Access Compliance Report Public Rights-of-Way (Curb Ramps)

Intersection ID: 29777 Main Street: REA_RD Cross Street: WILLIAMS_POND_LN Location: W

ADA ID: 1F2DA4F315FA Ramp Type: Perp Initial Pass/Fail: Fail Overall Compliance: No Severity Score: 13.75

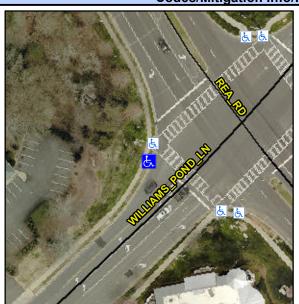
PROW/ADA:
R304.2.2

Compl	iance Description	Data	Compl	liance	Description	Data
N/A	Ramp Length (in)	101.0	No	Ramp	Slope (%)	8.8
Yes	Ramp Width (in)	53.0	Yes	Ramp	XSlope (%)	2.4
N/A	Flare Type LT	N/A	N/A	Flare	Type RT	N/A
N/A	Flare Slope LT (%)	N/A	N/A	Flare	Slope RT (%)	N/A
N/A	Flare Traversable LT?	N/A	N/A	Flare	Traversable RT?	N/A
N/A	Landing Length (in)	N/A	N/A	DWS	Provided?	N/A
N/A	Landing Width (in)	N/A	N/A	DWS	Contrast?	N/A
N/A	Landing Slope (%)	N/A	N/A	DWS	Length (in)	N/A
N/A	Landing X Slope (%)	N/A	N/A	DWS	Full Width?	N/A
N/A	Landing Curb? (Y/N)	N/A	N/A	DWS	Offset (in)	N/A
N/A	Shared Landing?	N/A				
N/A	Gutter Ponding?	N/A	N/A	Gutte	r Slope (%)	N/A
N/A	Gutter Lip Ht (in)	N/A	N/A	Gutte	r X Slope (%)	N/A
N/A	Painted X Walk1?	Yes	N/A	Paint	ed X Walk2?	N/A
	X Walk 1 Direction	To SE		X Wa	lk 2 Direction	N/A
N/A	X Walk 1 Width (in)	135.0	N/A	X Wa	lk 2 Width (in)	N/A
	X Walk 1 Slope (%)	1.9		X Wa	lk 2 Slope (%)	N/A
	X Walk 1 X Slope (%)	2.4		X Wa	lk 2 X Slope (%)	N/A

Remove & Replace Entire Ramp.
Restripe Crosswalk.
